Product Change Notice (PCN)

PCN Number: **PCN-0455007R**

Product(s) Affected: **PJ-036AH-SMT-TR**

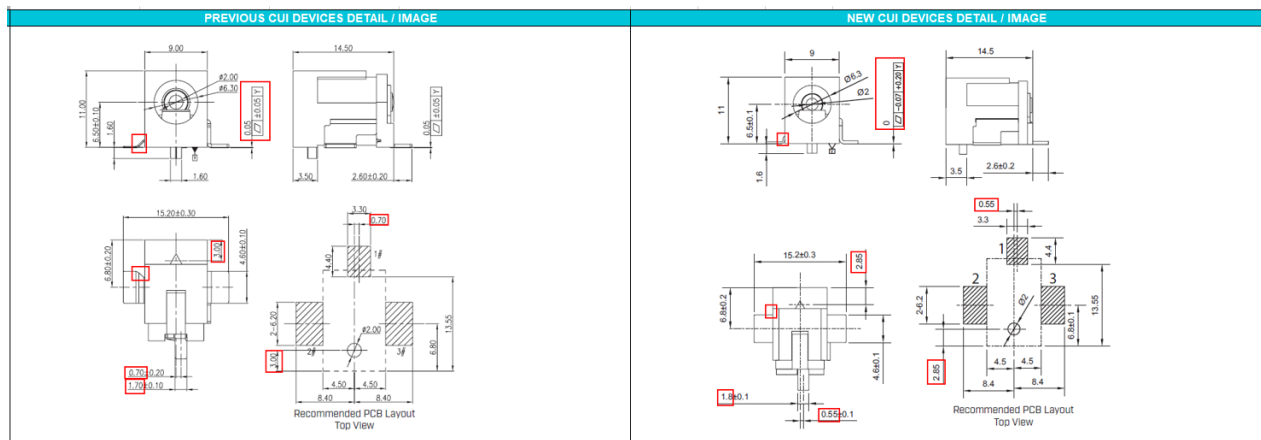
Description of Change: **Product re-engineered for improved manufacturability and production yield. Coplanarity specifications changed. Shape of terminal 2 changed. Location and size of terminal 1 changed. Locating post PCB hole location changed. See image below for reference and check CUI Devices website for updated drawing. Cosmetic differences may be visible and not affect the form fit and function of the product.**
